**CENTER FOR DRUG EVALUATION AND
RESEARCH**

204442Orig1s000

OTHER REVIEW(S)

SUBJECT: Inter-Center consult requested by CDER/OND for NDA
204442

Figure 1: Probuphine Applicator and Components

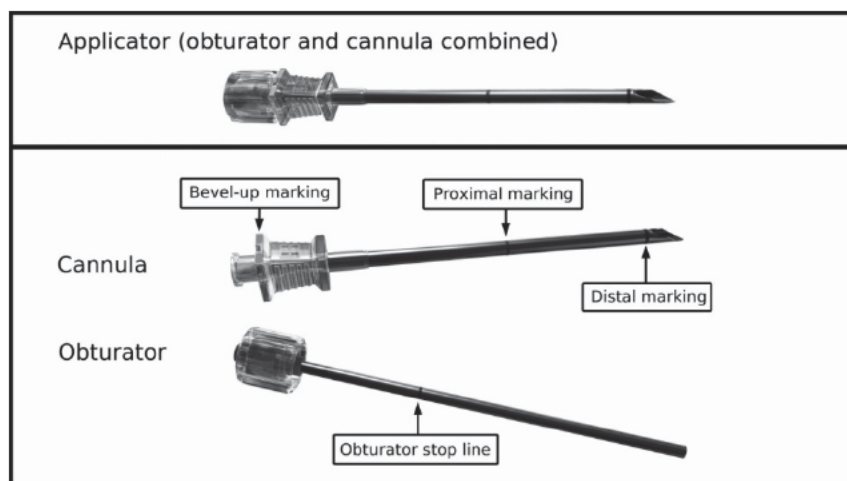
- d. Consider revising images of the cannula and obturator in Figure 1 (the applicator and its parts) to increase the visibility of the cannula's bevel-up marking, proximal marking and distal marking, and the obturator's stop line.

Figure 1. Incision for removal of Probuphine implants

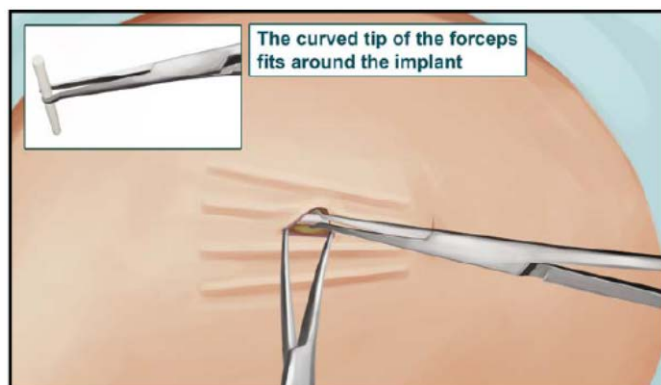
Among the concerns relating to the insertion/removal procedures identified in the first review cycle was the “U-technique” used for removal of the buprenorphine rods (see Figure 1). This technique is not commonly practiced in the US, and its adoption was a subject of questions raised by gynecology experts at the 2013 Advisory Committee meeting.

Figure 1: Probuphine Applicator Components

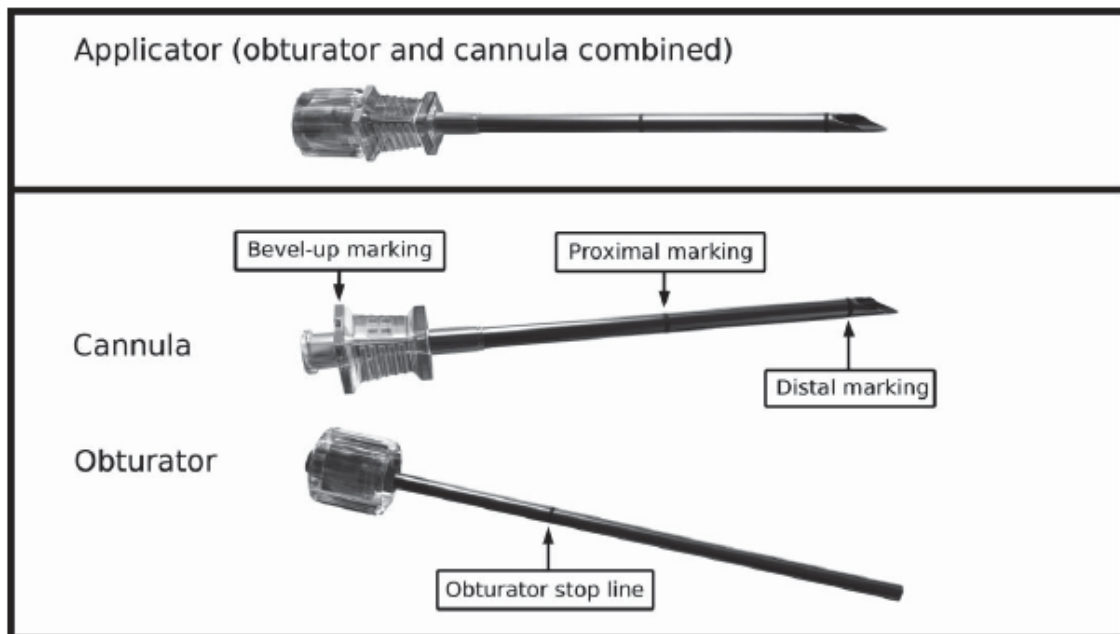
7. Consider revising images of the cannula and obturator in Figure 1 (the applicator and its parts) to increase the visibility of the cannula's bevel-up marking, proximal marking and distal marking, and the obturator's stop line.
